New Albany Planning Commission Agenda

FDM-106-2021 Final Development Plan

OXFORD LOT 1 FINAL DEVELOPMENT PLAN MODIFICATION

Planning Commission Staff Report November 15, 2021 Meeting

Conceptual Rendering of Final Development Plan Requirement

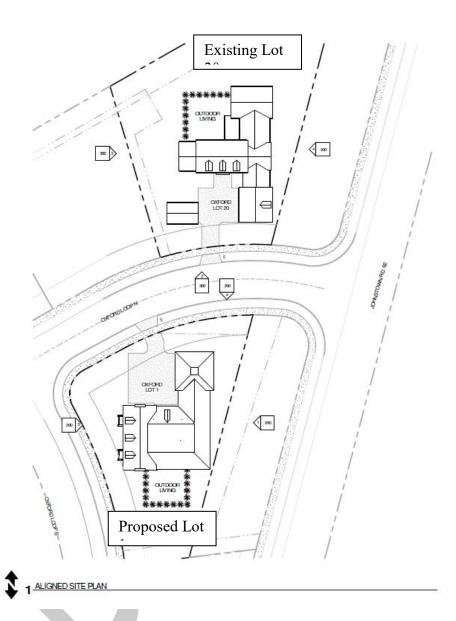
- 4. The intent of this requirement was to create a gateway as you drive into the Oxford subdivision and at the time, it appeared that the most appropriate way to accomplish this was to require the homes to be built up to and parallel to the US-62 right of way as shown in the conceptual rendering submitted with the previous final development plan modification on the next page. This requirement ensured that homes would not back onto US-62 as which is a residential development standard found in the Engage New Albany Strategic Plan.

- 5. As the subdivision has developed, it has become clearer that while it is still important to maintain a strong gateway into the subdivision along US-62, there are more ways than one to accomplish this gateway other than the requirements of the original final development plan.
- 6. The Planning Commission approved the existing home orientation of lot 20 as shown below. While not being parallel to US-62, the home on lot 20 provides an appropriate gateway into the subdivision as it properly addresses Oxford Loop and the curvature of the internal subdivision road. As proposed, both lots will appropriately address one another, provide an

appropriate gateway into the subdivision and not back onto US-62 all of which accomplish the original intent of the final development plan requirement.

Staff recommends approval of the application should the Planning Commission find that the application has sufficient basis for approval. Staff is supportive of the proposed design for lot 1 as it matches the design for lot 20 that was approved by the Planning Commission. This design meets the original intent of the final development plan which was to create a gateway into the Oxford subdivision and not back homes onto public streets which is an important development standard found in the Engage New Albany Strategic Plan. The proposed home orientation allows the home to address the curvature of internal streets rather than having them be built up to the US-62 build-to-line and still accomplish the goals of the requirement. Additionally, there are existing entry features and landscaping along US-62 that aid in establishing a gateway into the subdivision. The home utilizes four-sided architecture that properly addresses US-62 and meets all other code requirements.
